UNITED STATES PATENT AND TRADEMARK OFFICE

Office Action Summary	Application No. 10/560,148	Applicant(s) BANTLE, ULRICH	
	Examiner Kristina R. Fulton	Art Unit 3673

DETAILED ACTION

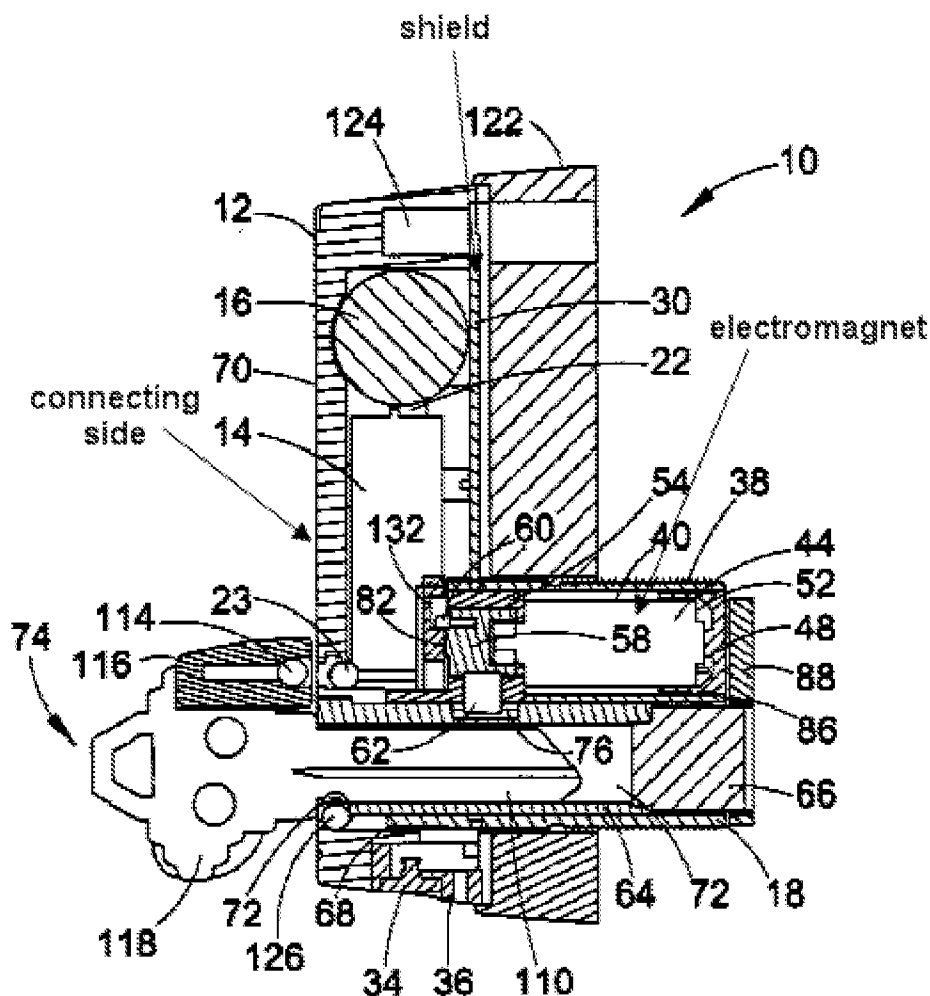
6. Regarding claim 2, the housing has a connecting side on which the handle is arranged, and the shielding element is positioned between the at least one of the armature and the electromagnet and the connecting side (see illustration below).

12. Regarding claims 8 and 16, wherein a permanent magnet (102) is assigned to an end of the armature that is opposite the locking element, which maintains the armature in an opening state, a magnetic force is applied to the armature by the electromagnet which acts counter to a force of the permanent magnet, and a spring (96) is assigned to the armature which in the open state applies a spring force acting in a closing direction to the armature (column 6, lines 33-37). See the Meekma device below.

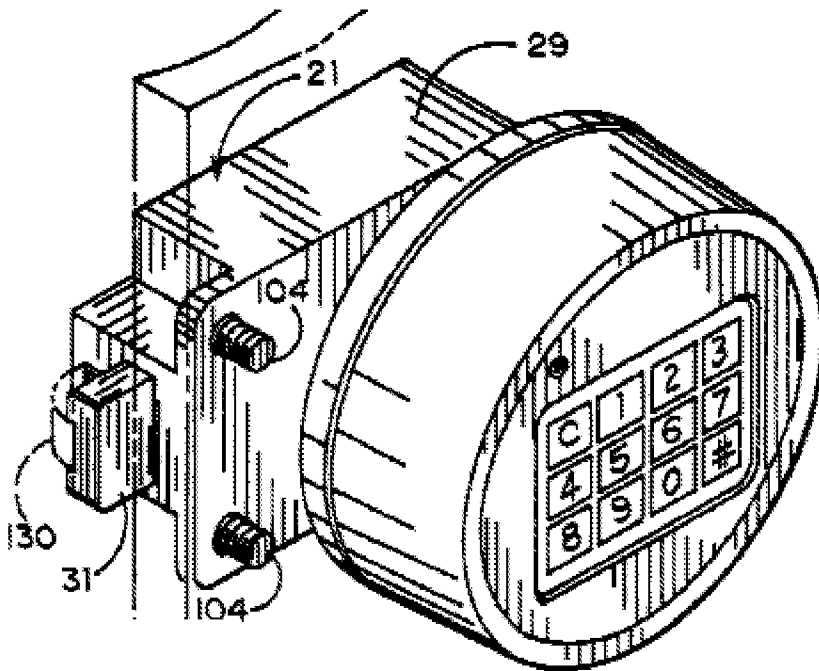
15. Claim 18 is rejected by Meekma as applied to claim 8 above. See the Maniaci device below.
